ENCLOSURE 3

PROPOSED TECHNICAL SPECIFICATIONS

Marked-up Technical Specification/Technical Specification Bases Pages:

TS CHANGE, PART 1

Figure 2.1.1-1 (page 1 of 1)
Reactor Core Safety Limits

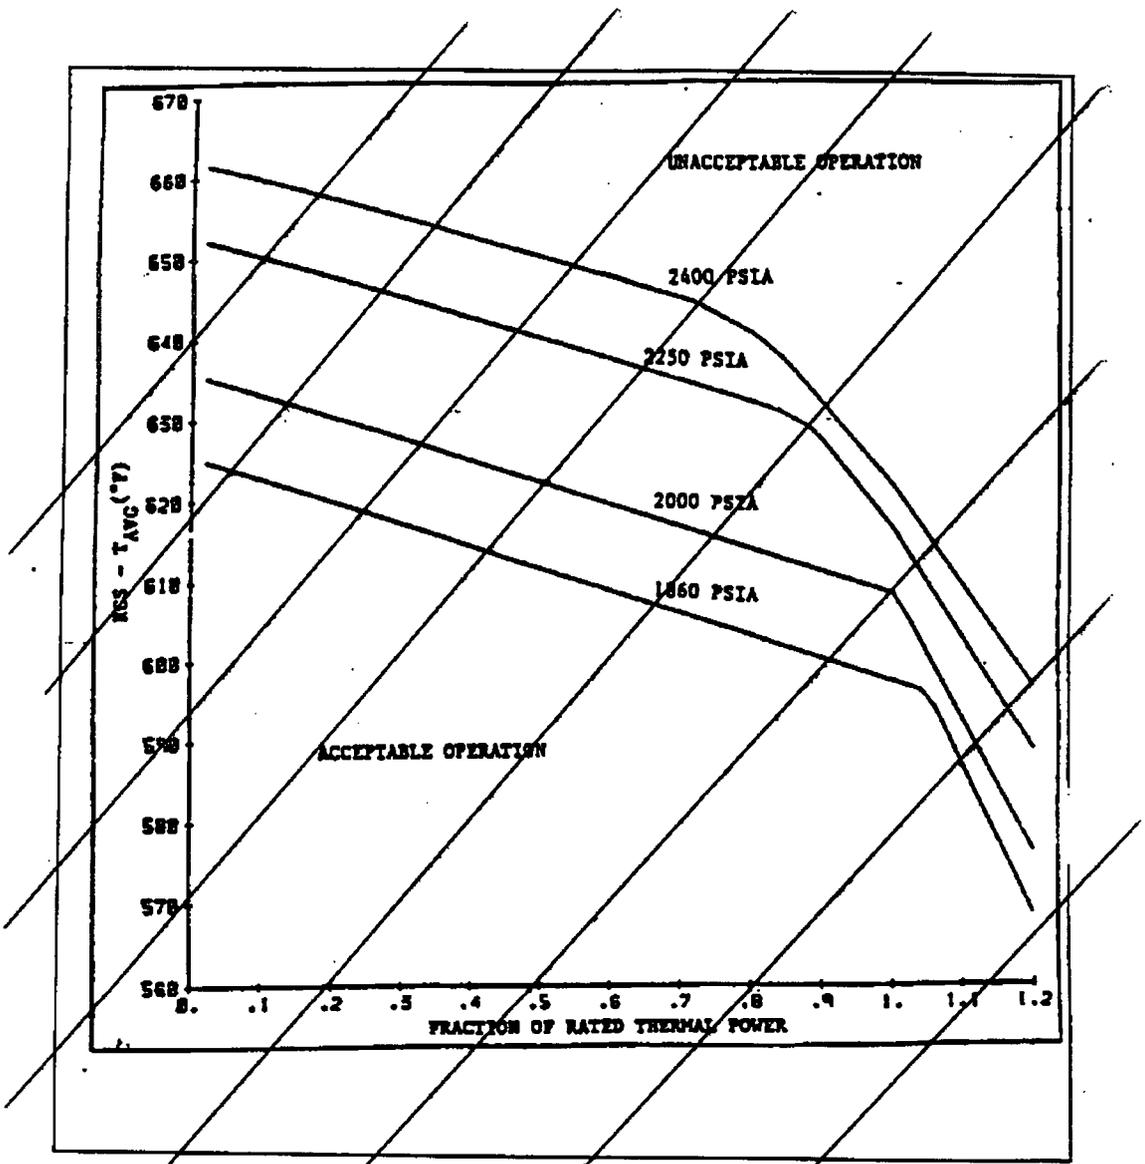
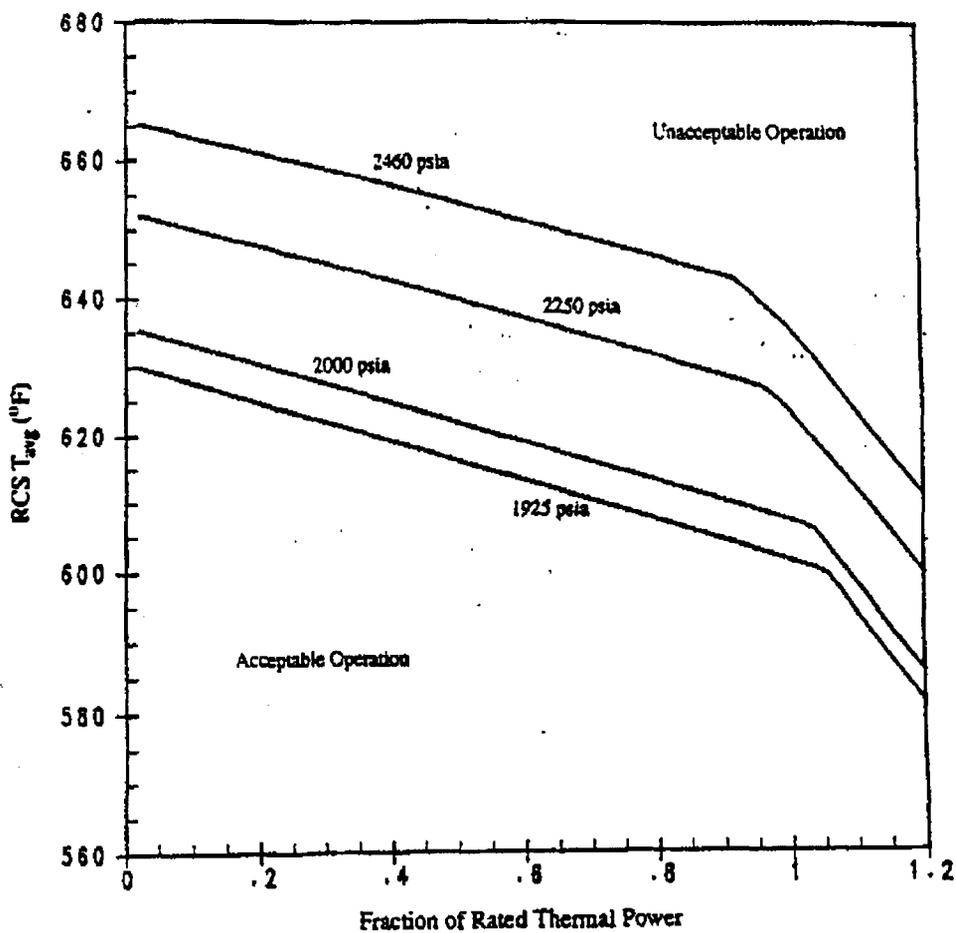
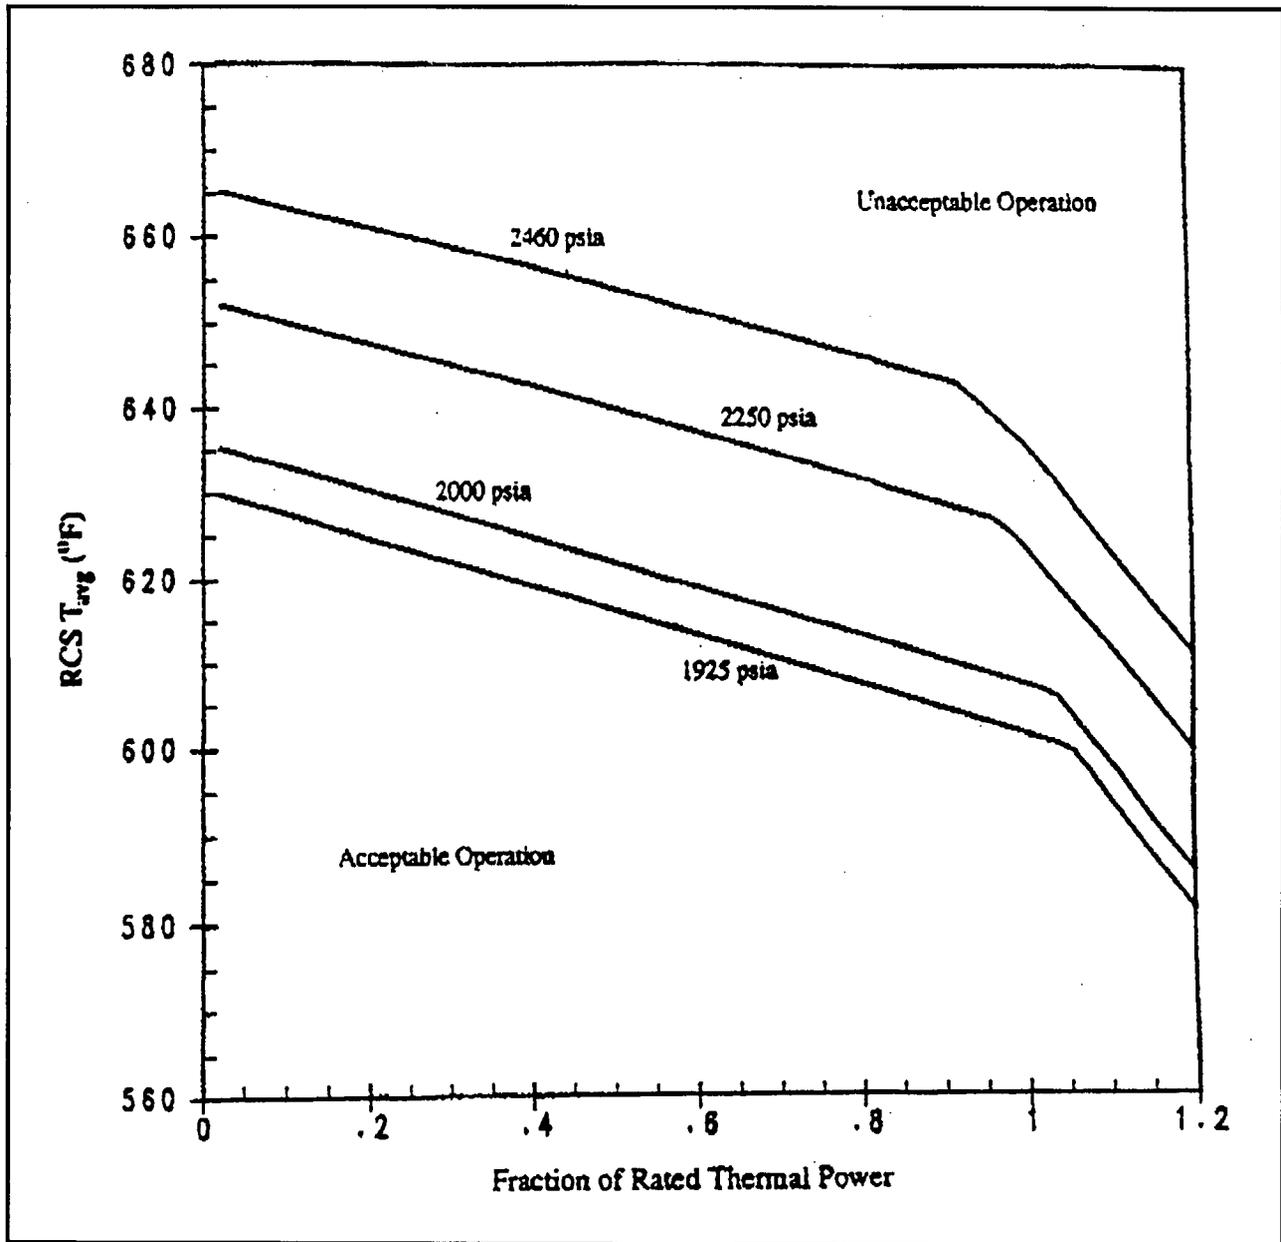
Replace with Insert 1

Insert 1 for page 2.0-2

Figure 2.1.1-1 (page 1 of 1)
Reactor Core Safety Limits
